**Item 4.****Development Application: 658-660 Botany Road, Alexandria - D/2018/871****File No.:** D/2018/871**Summary**

**Summary Recommendation:** The development application is recommended for deferred commencement approval.

**Figure 35:** South-west elevation showing application of 'Lady In Red' to facade.

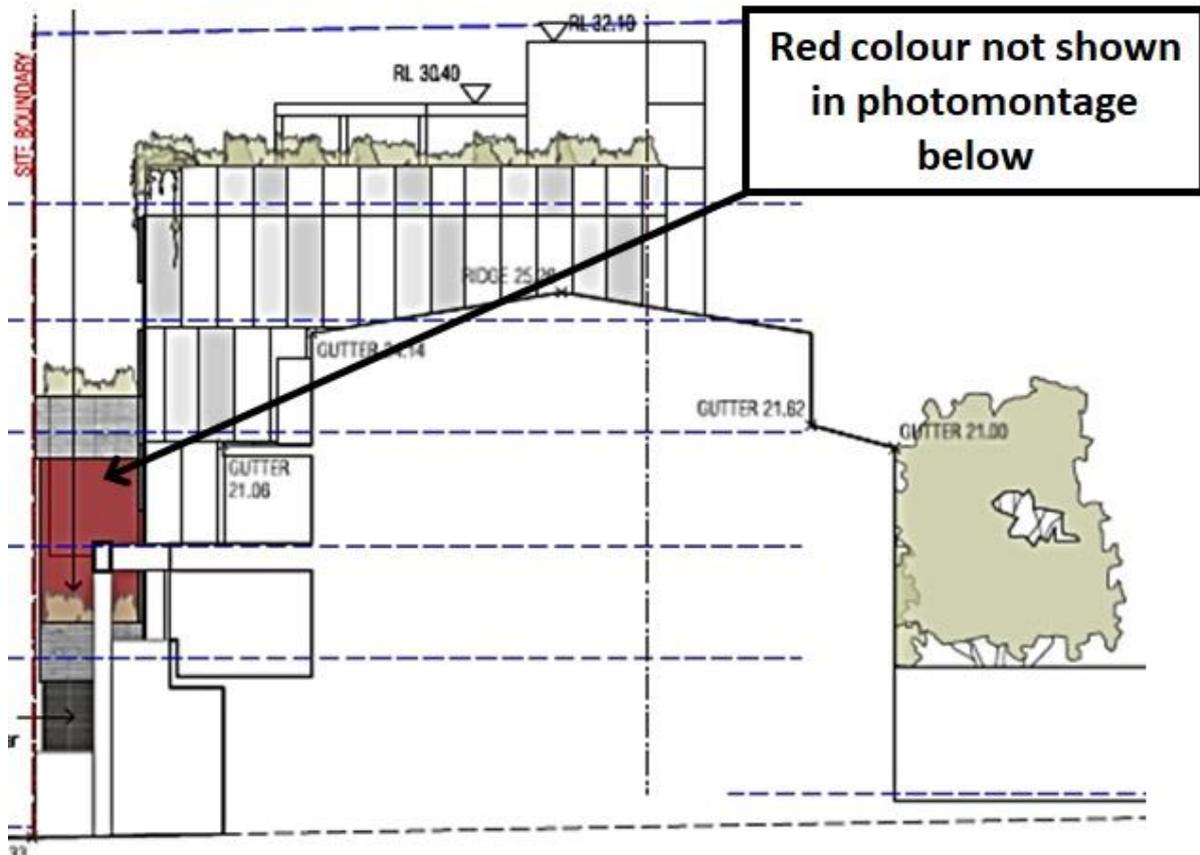
- (b) The use of the 'Lady in Red' colour on the south west elevation does not correspond to the submitted photomontages, as shown in the Figures below. A condition is recommended to delete the application of this colour to the external wall.

Figure 37: Typical layout of levels 2, 3 and 5 with windows facing gallery spaces.

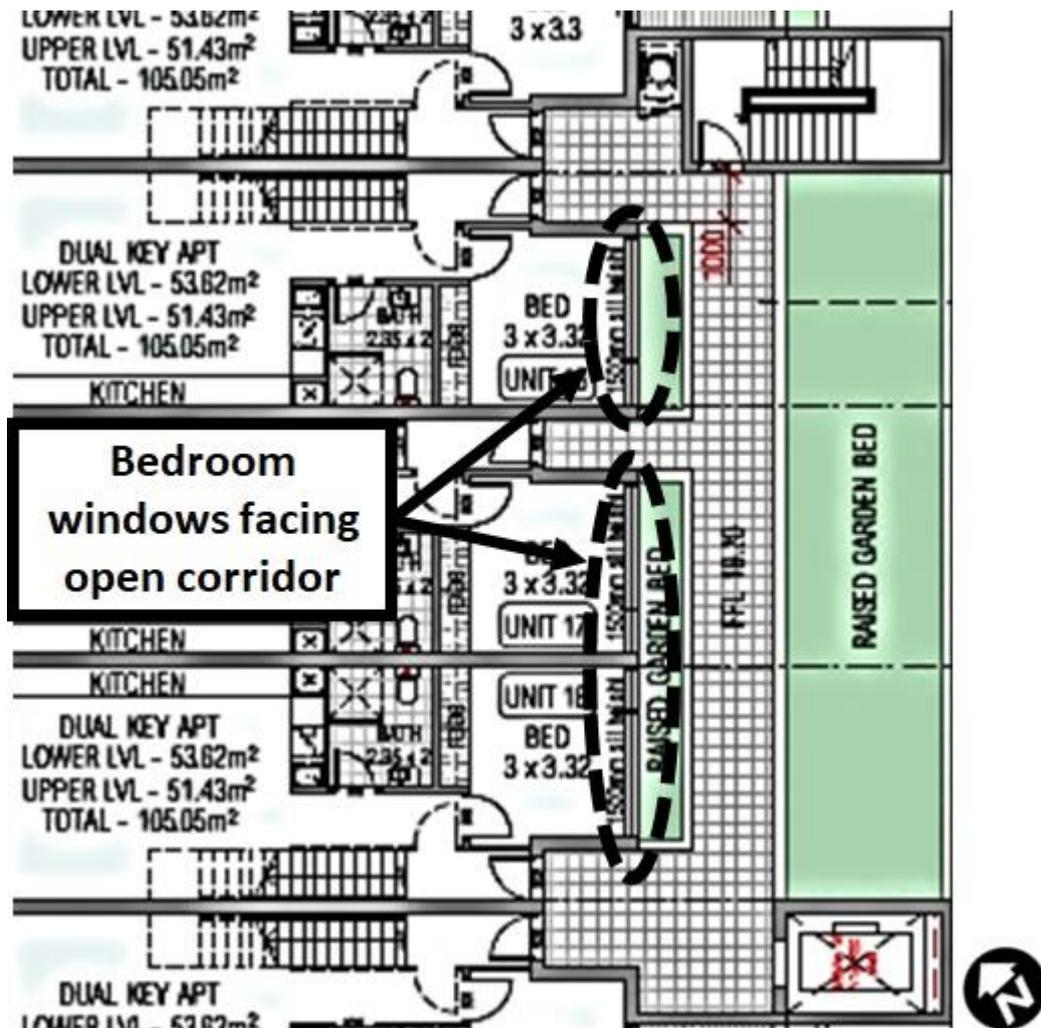
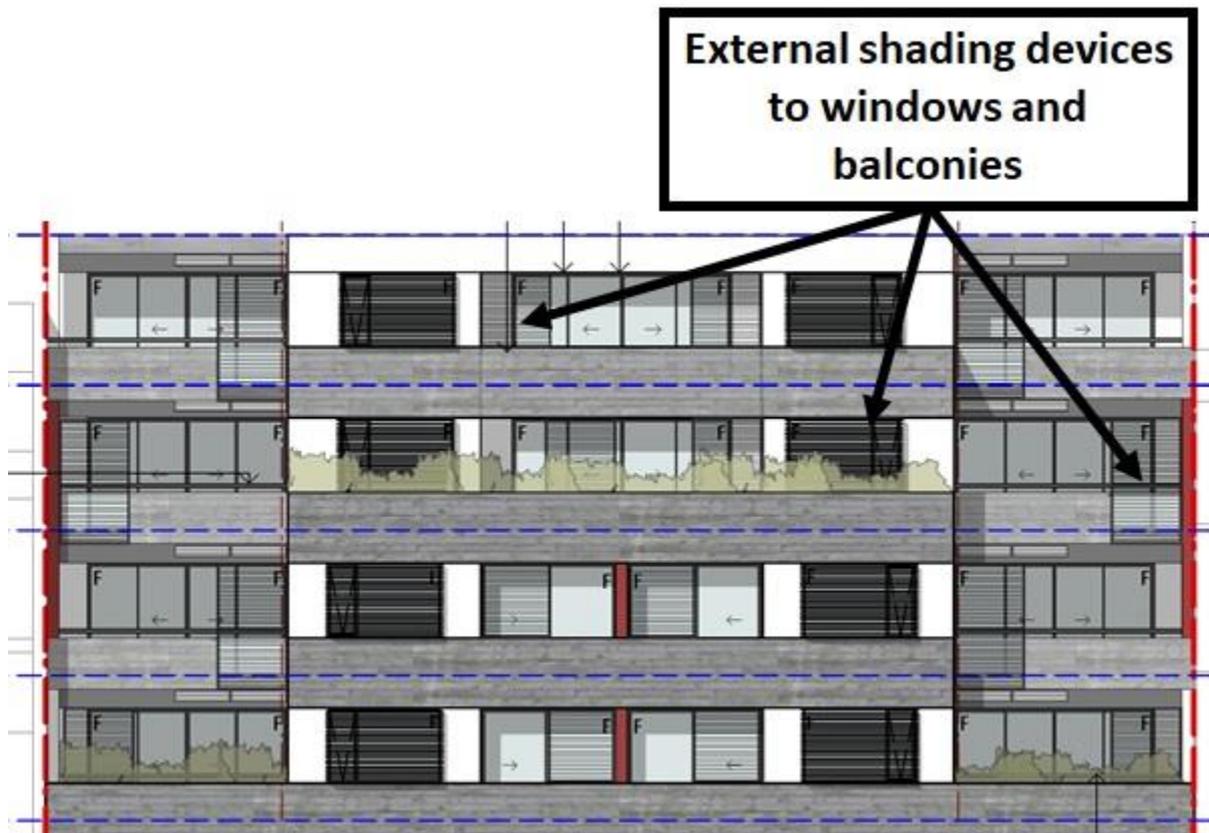
57. The open communal walkways adjacent to south-west facing bedroom windows to levels 2, 3 and 5 of the Botany Road building, shown in the Figure below, will diminish the level of visual privacy provided for residents of these apartments.

58. South-west facing bedroom windows to levels 2, 3 and 5 of the Botany Road building will rely on acoustically attenuated ventilation plenums and suitably thick glazing, to achieve the requisite internal noise levels within these bedrooms. As such any noise generated by those using the adjacent open walkways will be ameliorated by these acoustic treatments.
59. In satisfying ADG acoustic privacy and natural ventilation requirements, the result has been a variation from the ADG objective 3F-2 design guidance, which is to separate habitable rooms from gallery access and open circulation space by apartments' service areas.
60. Council's Urban Design Specialist has recommended a condition for external louvres to be applied to these windows to improve the level of visual privacy provided to these bedrooms.

**Figure 38:** Proposed sun-shading to north-west (Birmingham Street) elevation.

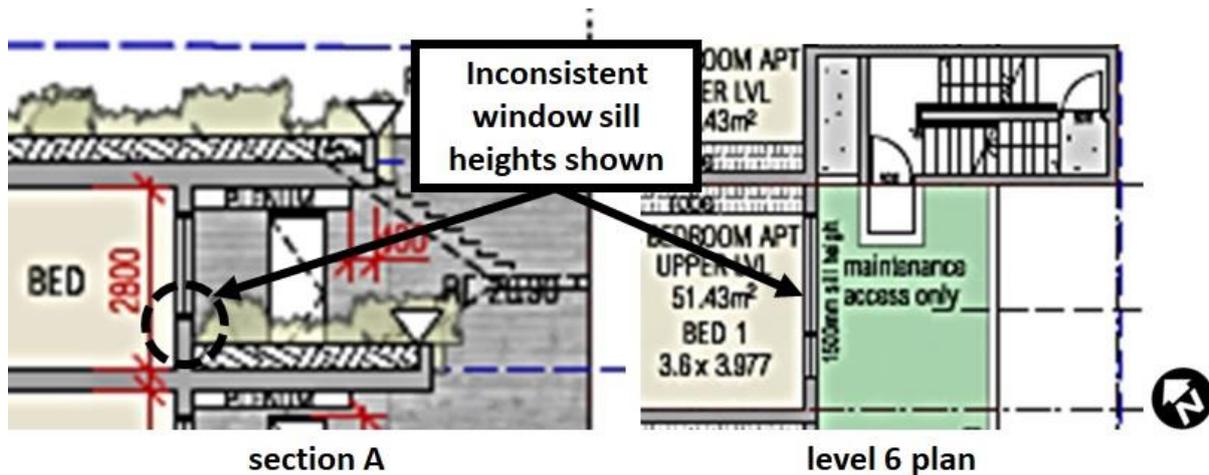
61. The north-west (Birmingham Street) elevation shows horizontal louvres to provide sun-shading to windows in this elevation, as shown in the Figure below.

62. While this is supported in principle, inadequate information has been provided about operability of the louvres themselves and whether they are adjustable to cope with low altitude summer sun or retractable to allow more sunlight into apartments during winter.
63. Council's Urban Design Specialist has recommended conditions for:
- (a) horizontal louvres to windows in the north-west (Birmingham Street) elevation to be adjustable, retractable louvres with manufacturer's details to be submitted to and approved by Council officers; and
  - (b) adjustable, retractable shading to be applied to the internal north-west elevation to provide adequate sun-shading to these windows also.

**Figure 39:** Section and level 6 plan show inconsistent sill heights.

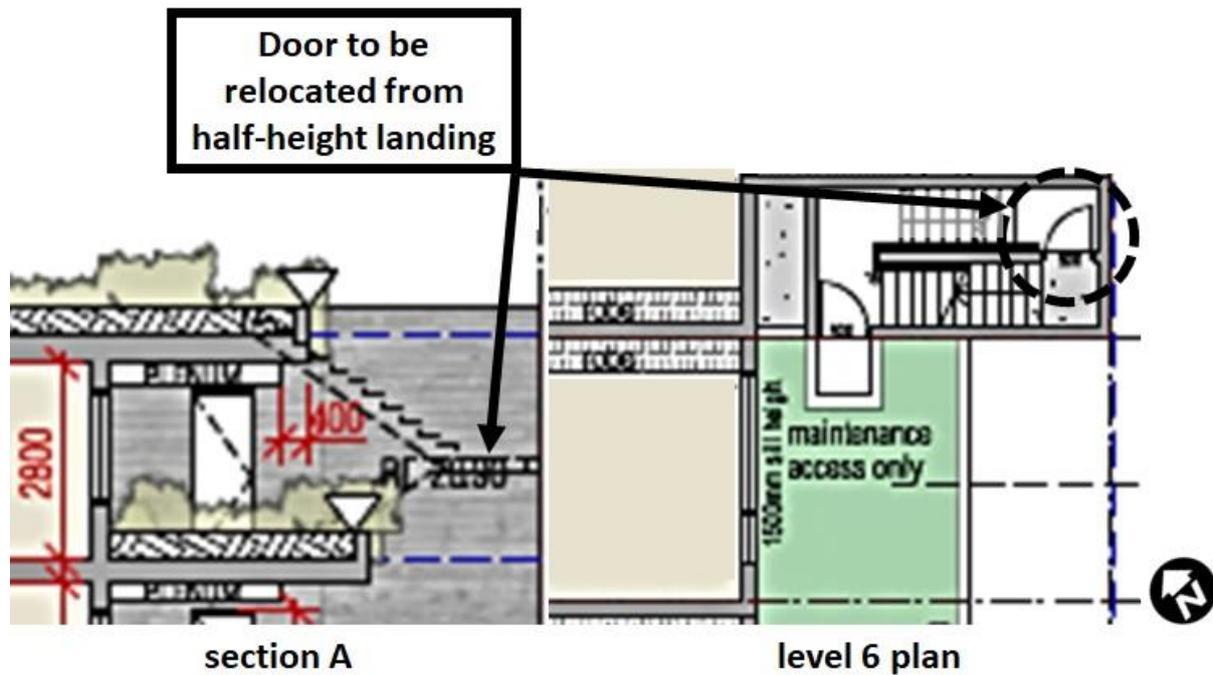
64. Level 6 bedrooms with a south-east facing window to Botany Road are notated as having a 1.5m high sill height and which is inconsistent with the lower sill height (approximately 0.8m) shown in section in the Figure below.

65. The sill heights of the Level 6 bedroom windows to Botany Road create a potential safety problem, if they were not designed to prevent access to the garden planter. The garden planter does not have a BCA compliant balustrade to its outer edge. Also a potential security problem in that the windows could allow access from the maintenance access door from the north-western stairwell. It is also noted that the level 6 plan is inconsistent with the level 6 landscape plan.
66. Council's Urban Design and Landscape Design Specialists have recommended conditions for:
- (a) the Level 6 bedroom windows to Botany Road to be designed to prevent access to the adjacent garden planter; and
  - (b) for design modifications to address consistency of design details of Level 6 bedroom windows to Botany Road to be consistent across all relevant architectural and landscape design drawings.

**Figure 41:** Ground floor plan of neighbouring development at 662-674 Botany Road.

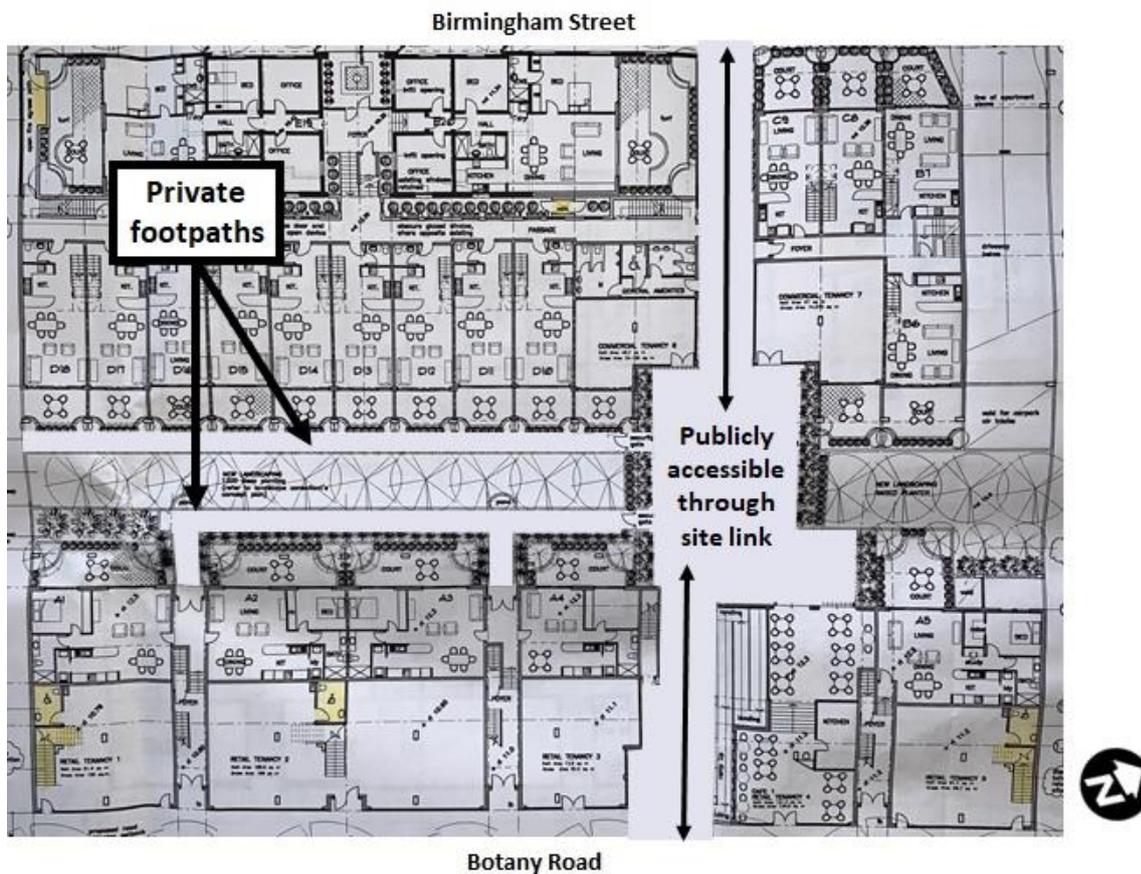
As shown in the Figure below, the neighbouring development at 662-674 Botany Road does not have common open space as it is defined in the ADG and DCP. Rather it has a publicly accessible through site link and secure gates to footpaths that provide access for residents to the courtyards of ground floor apartments.
